RE: CRIST ELECTRIC GENERATING PLANT
REQUEST FOR ADDITIONAL INFORMATION RESPONSE
UNIT # 7 ESP & SCR Project No: 0330045-005-AC

GULF POWER'S RESPONSE TO FDEP'S REQUEST FOR ADDITIONAL INFORMATION DATED JANUARY 22, 2003 UNIT 7 ESP/SCR PROJECT - Project No: 0330045-005-AC

Re: **Request for Additional Information**
Project No. 0330045-005-AC
Crist Unit 7 ESP/SCR Project

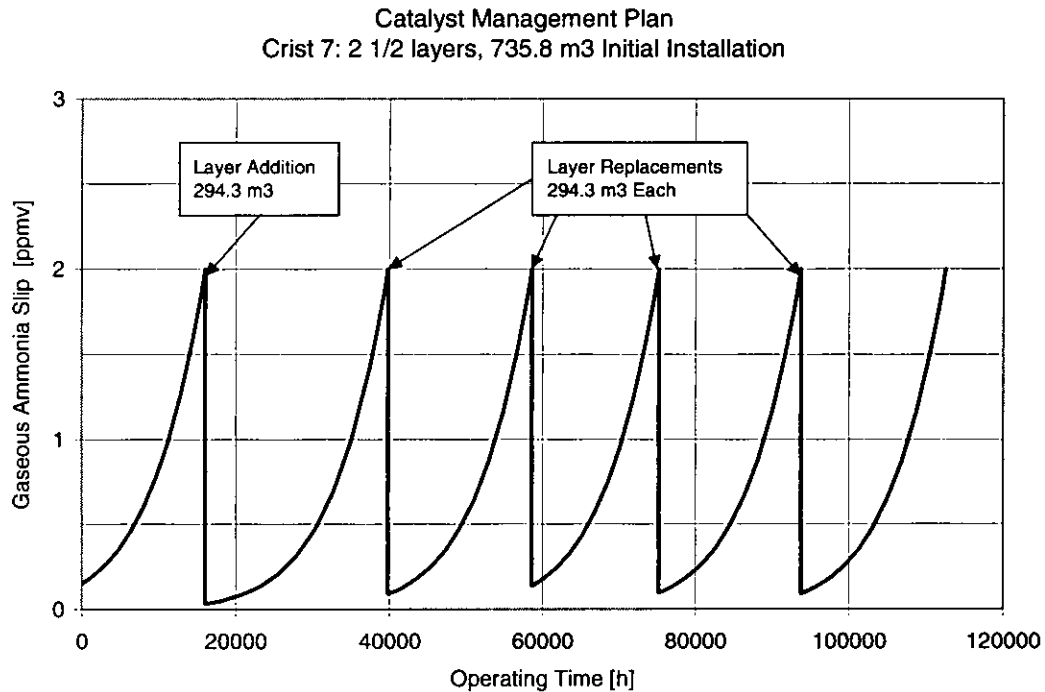
- n. Describe the design and operating techniques used to prevent particulate matter from fouling and masking the catalyst beds.*

Large “popcorn” ash particles have the potential to plug the protective screens on catalyst modules and may even plug the catalyst elements themselves. This pluggage leads to poor gas distribution within the SCR, higher draft loss across the SCR and a reduction in catalyst life. Large (>4mm diameter) particles must be collected before they reach the catalyst. Flyash particles must be kept moving through the catalyst and not allowed to accumulate.

Flow model studies of the SCR system are being conducted using both numerical and experimental methods. The numerical method uses computational fluid dynamics (CFD) to predict flow patterns and particle behavior throughout the system. The experimental method includes a 1/12th scale model of the SCR system. Fans force air to flow through the model at velocities selected for similitude across the operating range of the full scale reactor. Gas flow patterns in the model are observed using smoke, tracer gas and tufts of yarn. Areas of ash deposition are observed using cork dust to simulate flyash. Gas flow distribution devices and popcorn ash collection devices are developed and tested.

The SCR inlet duct is designed to facilitate collection and removal of large ash particles. The 90 degree bend upward from the economizer outlet duct provides the change of flow direction necessary for momentum-based devices such as deflector plates. The large cross-sectional area is sized for low velocity (35 feet/second) with upward vertical flow. This allows particle screens to be used with minimal abrasion and draft loss. Devices of these types will be tested and proven as part of the flow model study.

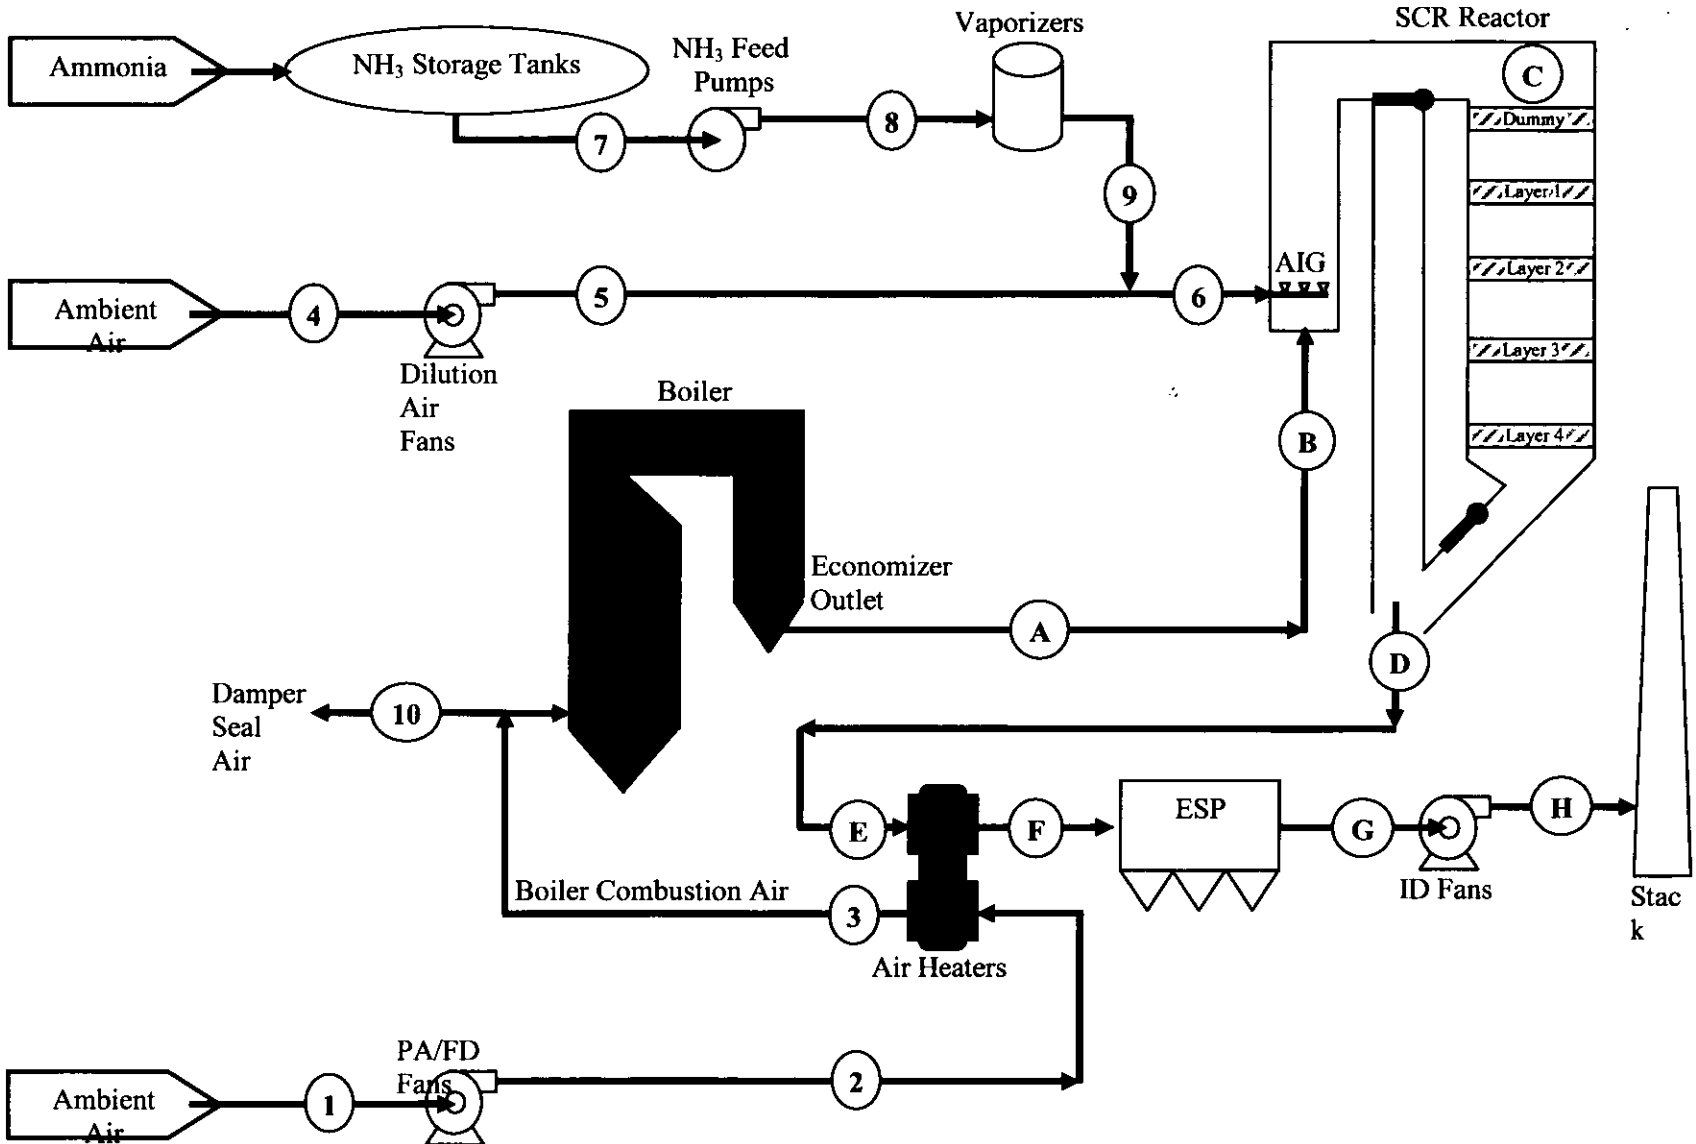
4. **SCR Bypass Duct:** Describe the general location and operation of the proposed SCR bypass duct. Under what conditions is it necessary to use the bypass? For each condition, estimate the duration of bypass operation and the number of times per year the bypass is expected to operate under the condition. Is Gulf Power requesting any specific permit conditions related to bypass operation? Please provide supporting documentation for any requests.

- a. *Describe the general location and operation of the proposed SCR bypass duct.* The SCR bypass duct is configured to allow boiler exhaust gas to bypass the SCR catalyst. Initial design locates it so the bypass inlet is at

the top of the SCR box and the outlet is at the bottom of the SCR box. Two large bypass dampers re-direct the gas flow through this duct. See EPS-3016-281. For a general understanding of bypass issues, two conditions pertaining to the SCR should be understood. First, the SCR reaction takes high temperatures for the chemical reaction to occur. These temperatures, around 600 degrees F, do not exist until the unit is loaded to approximately 275 MW. Second, a cold SCR must be gradually warmed to control thermal expansion.

Crist Unit 7 NOx Data

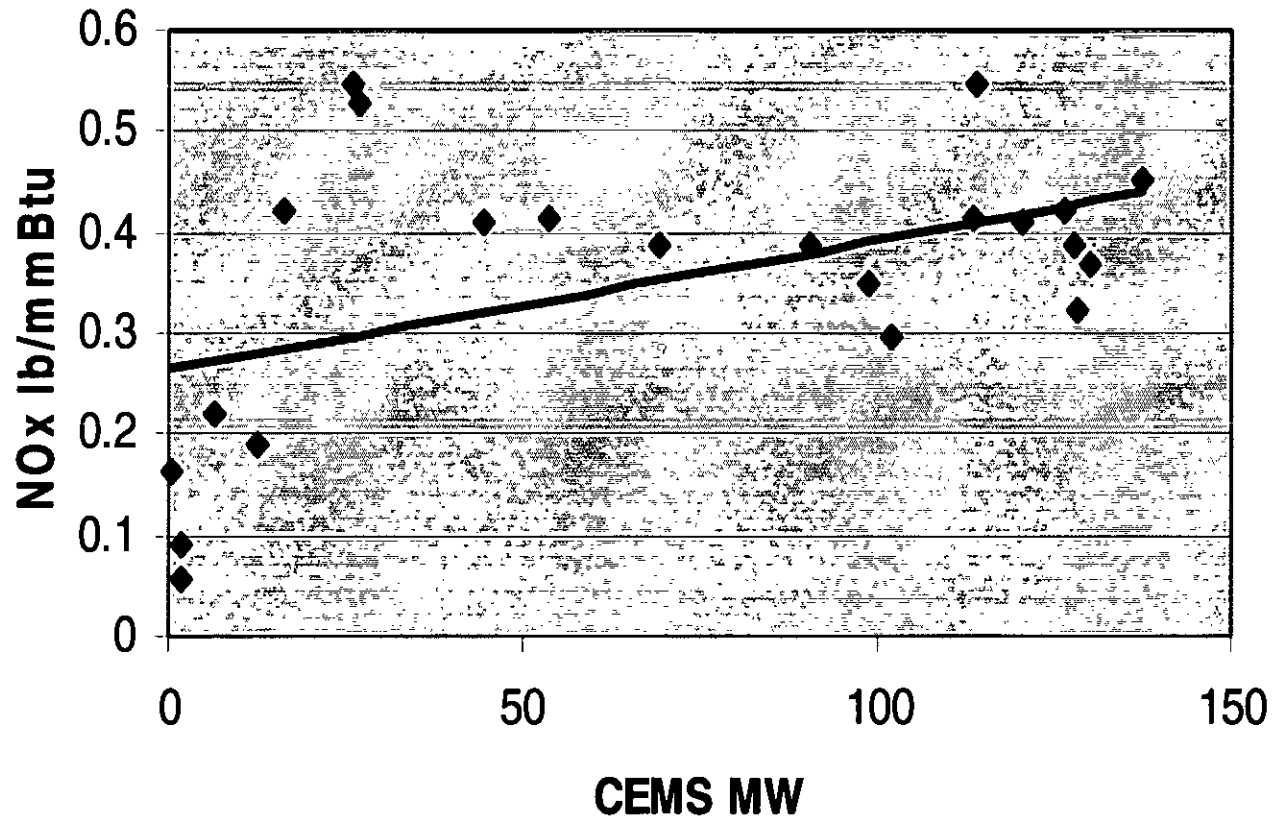
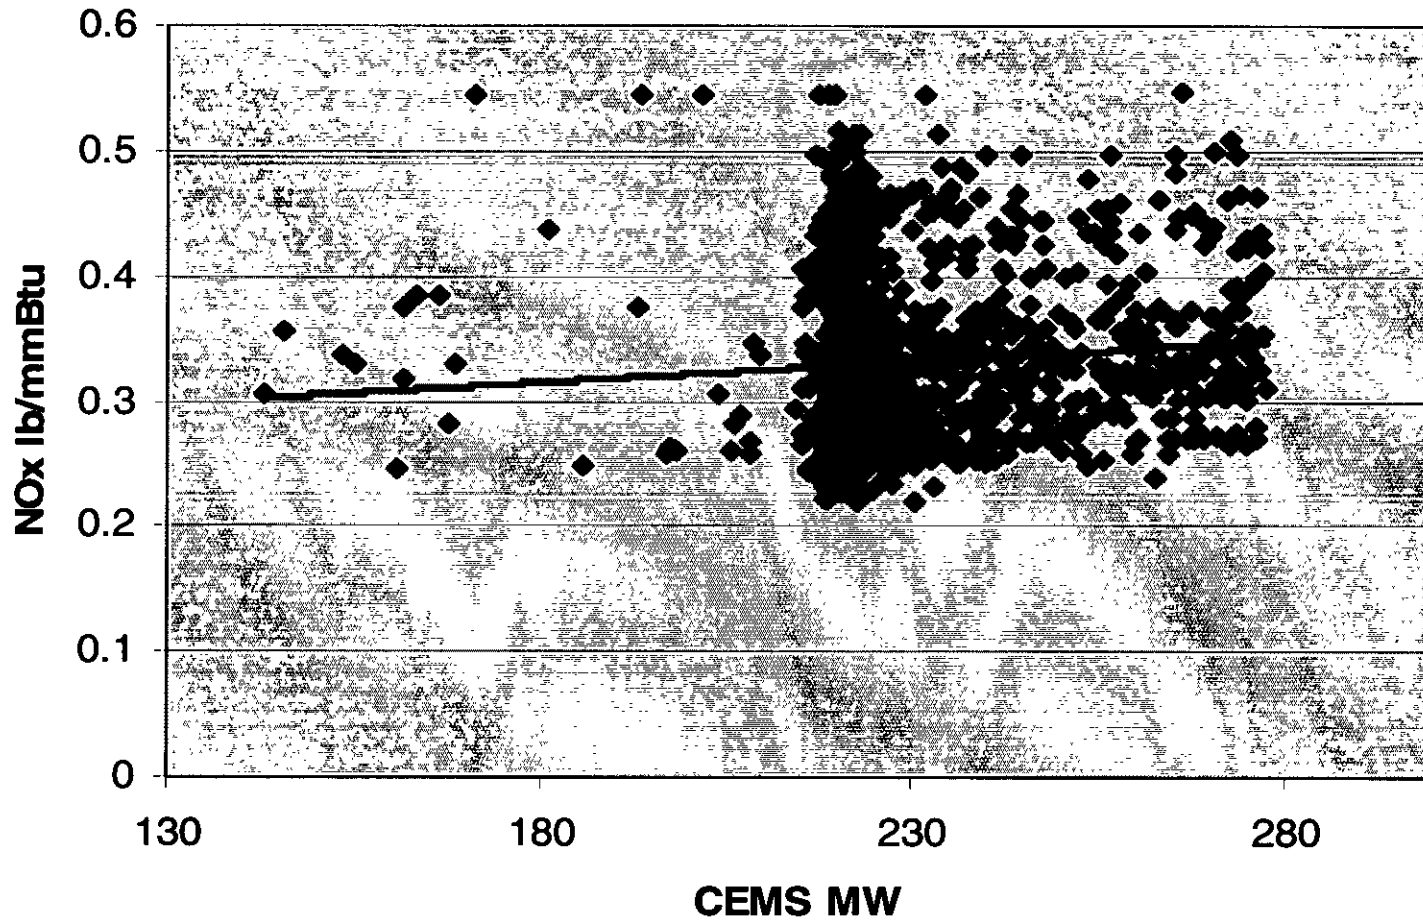
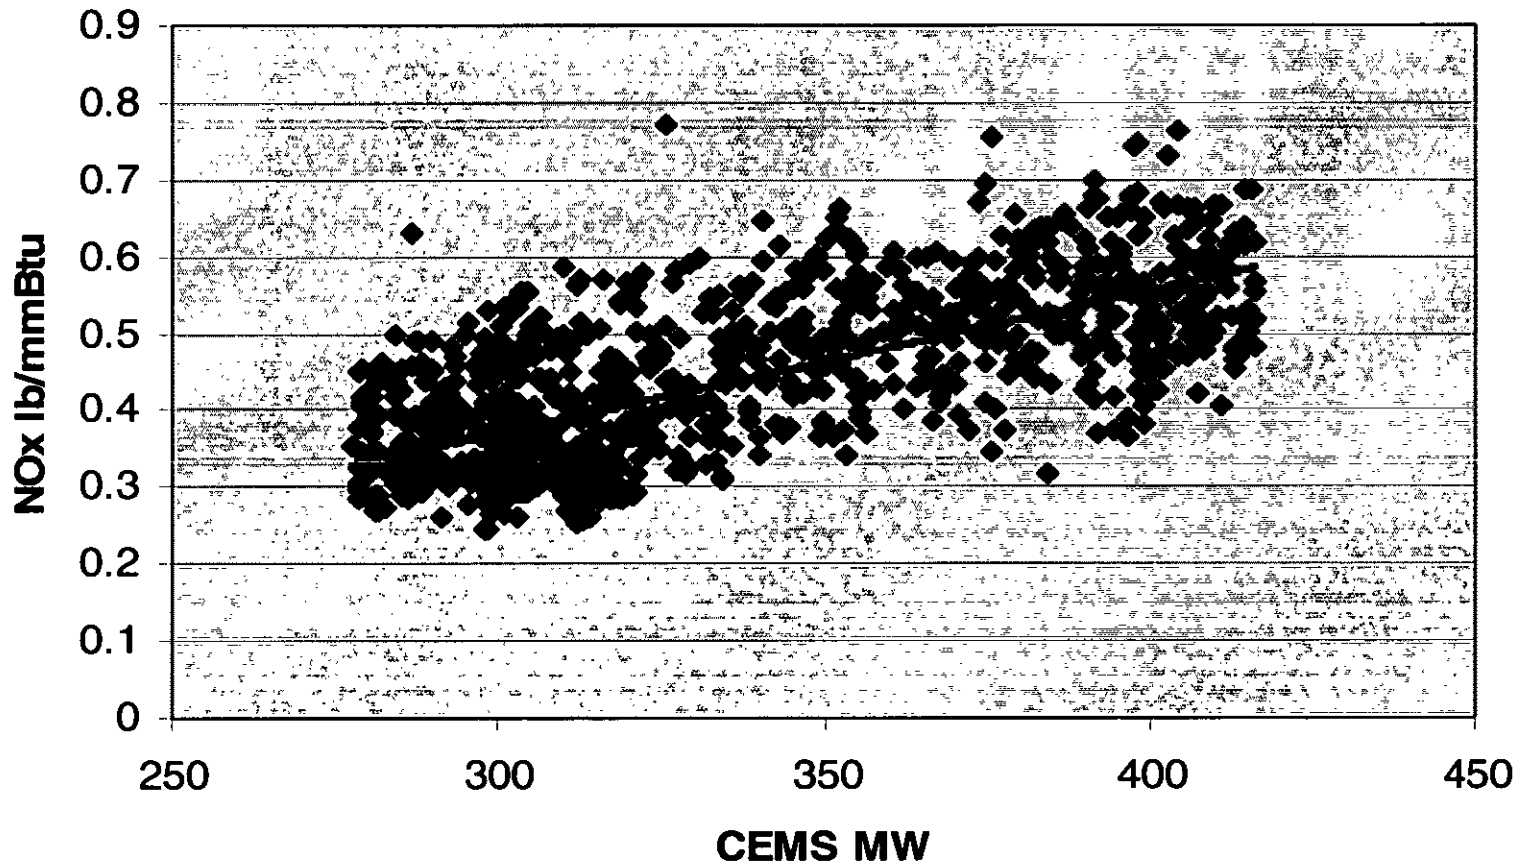
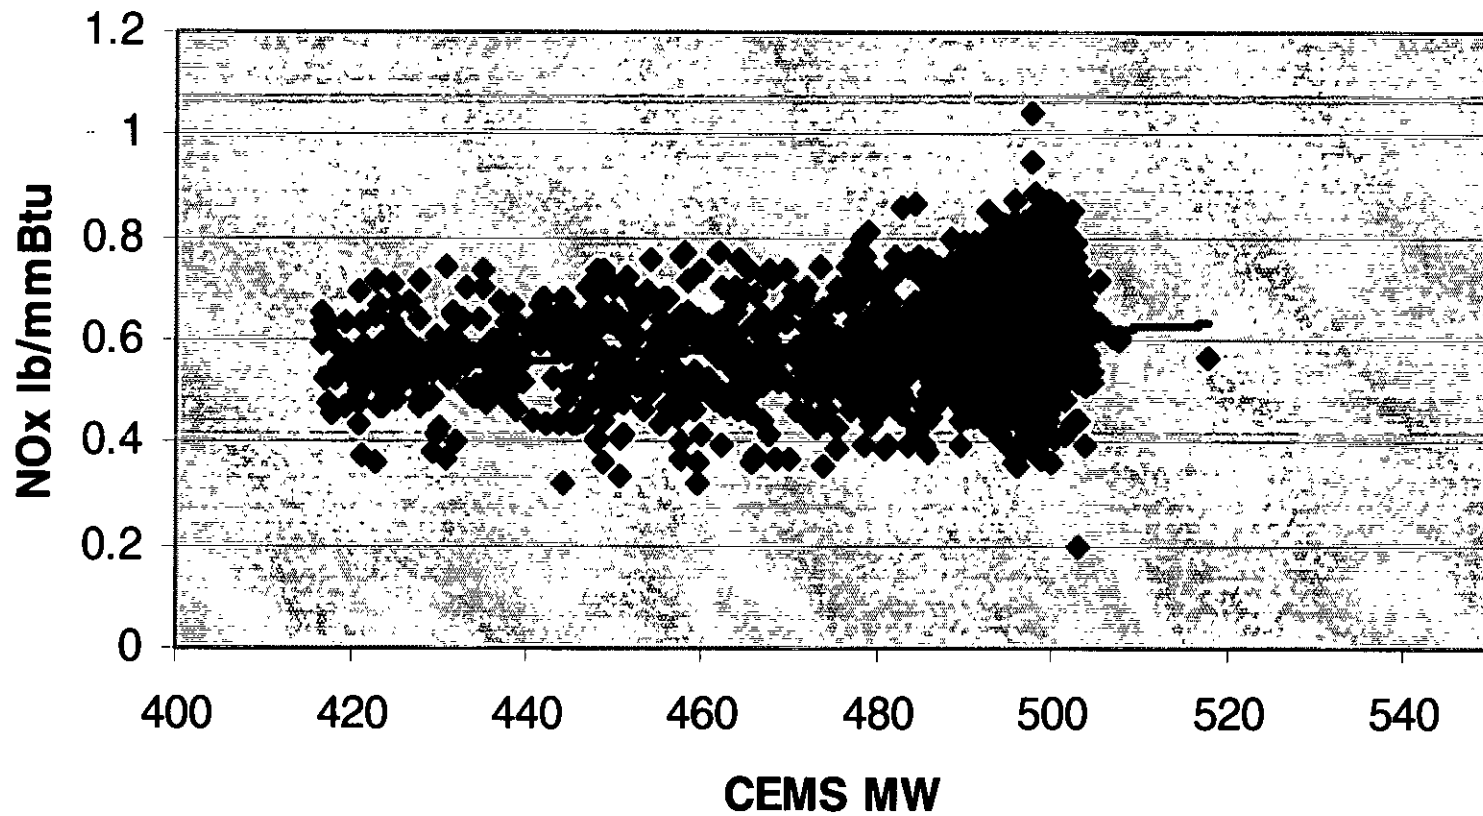
d. *Is Gulf Power requesting any specific permit conditions related to bypass operation? Please provide supporting documentation for any requests.*

Gulf Power believes operations during periods of startup, shutdown and malfunction do not constitute representative conditions for the purpose of performance testing and are exempt as excess emissions. Thus, the SCR bypass should be authorized for unit startup and shutdown including boiler and SCR maintenance as periods of malfunction. Gulf Power requests that bypass operation for boiler and SCR maintenance be permitted for 15 days during 2005 and up to 15 days per calendar year thereafter. During bypass operations the NOx emissions limit should be a 24 hour average at 0.35 lb/mmBtu from Crist Unit 7. These periods should not be included in the 30 day emission average for NOx. on a

daily average basis during those days. The proposed 0.35 lb/mmbtu limit is based on past actual operating data for Crist Unit 7 and is included as "Attachment A."

Gulf Power Proposal

- During periods of Crist Unit 7 SCR by-pass operation for maintenance or emergency operation allow NOx emissions rate at or below 0.35 lbs/mbtu.
- Gulf Power requests these operations be limited to no more than 15 days per year for routine maintenance activities and limited to case by case basis for emergency operations.
- Startup and Shutdown operations are exempt from all emissions averaging.
